Access Compliance Report Public Rights-of-Way (RR Crossings)

Intersection ID: 10025333	Main Street: E_6TH_ST	Location: N/A
ADA ID: 64444D97013A	Overall Compliance: No	Severity Score: 0.0
Codes/Mitigation Info/Possible Solution		Field Measurements/Component Compliance

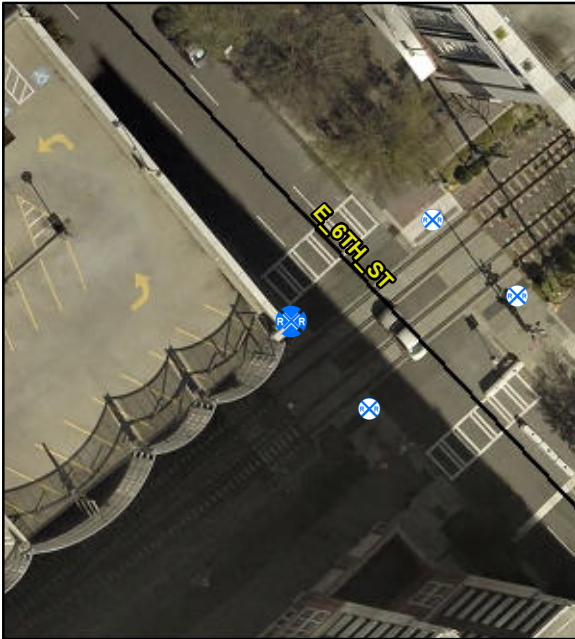
Compliance	Description	Data
Yes	DWS Provided?	Yes
Yes	DWS Contrast?	Yes
Yes	DWS Width (in)	Yes
Yes	DWS Length (in)	32.0
No	DWS Offset (in)	24.0
No	Pedestrian Gate?	No
N/A	DWS Outside Gate?	N/A
N/A	Rail Type?	LightRail
No	Flangeway Gap (in)	2.5
Yes	Sidewalk Width (in)	118.0

**Remove & Replace Detectable
Warning System. Provide Pedestrian
Gate. Remove & Replace Walking
Surface Adjacent to Rail.**
